## Power Equipment

CODE: CC-289 (REVISED 9/30/94. DESTROY ALL PREVIOUS COPIES)

SUBJECT: POWER TAKE OFF (PTO) CLUTCH FAILURES 2185 CUB CADET.

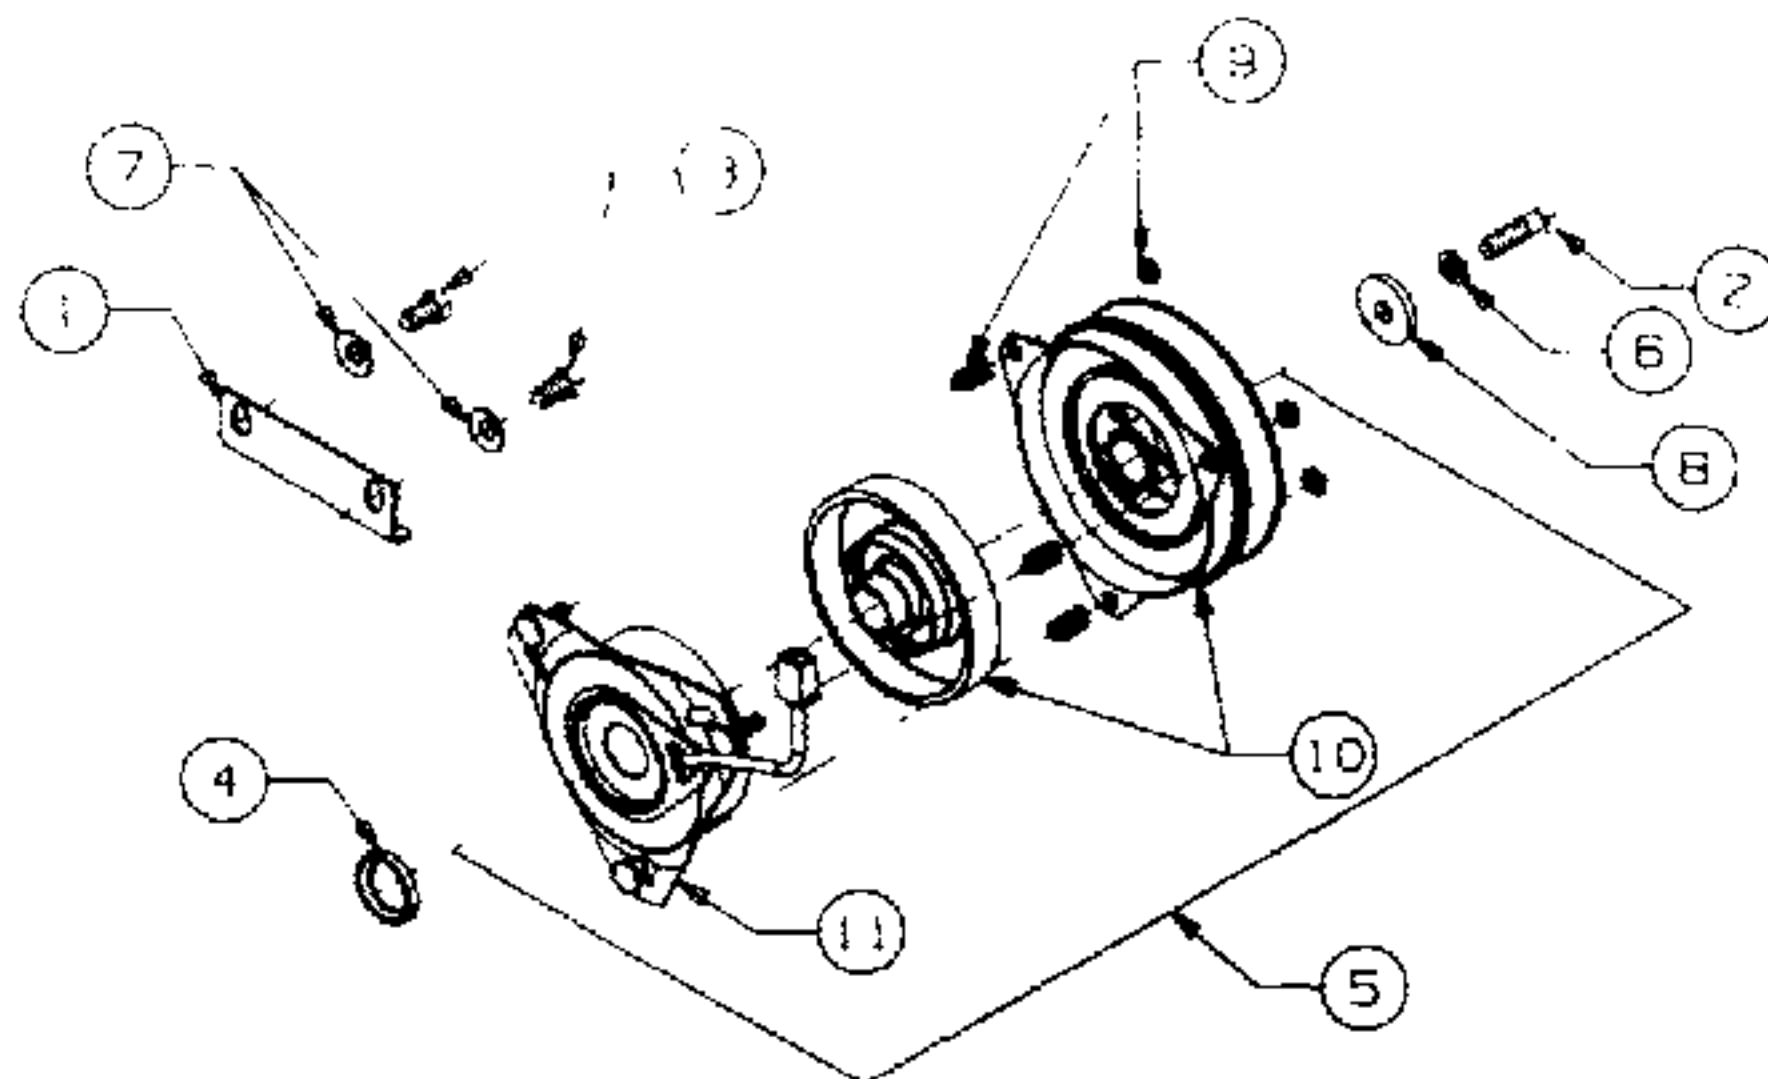
Reports from the field indicate difficulties with the above mentioned tractors PTO clutch including, clutch bearing failures, field winding failures or exposed field windings.

Failures seem to be caused by improper clamping of the PTO clutch to the engine crankshaft. If it does not fit tight against the spacer the above examples may occur. Should you experience the above symptoms or failures, the following should be done.

Order a second spacer, part no. 711-3396, (See fig. 4) and install it on the crankshaft with the existing spacer. Install the PTO clutch, making sure that the clutch fits against the spacers. Once it has been verified that clutch to spacer contact has been achieved, with no other interference, install the retaining bolt, lock washer and retaining washer into the crankshaft. Torque to 50-60 ft. lb..
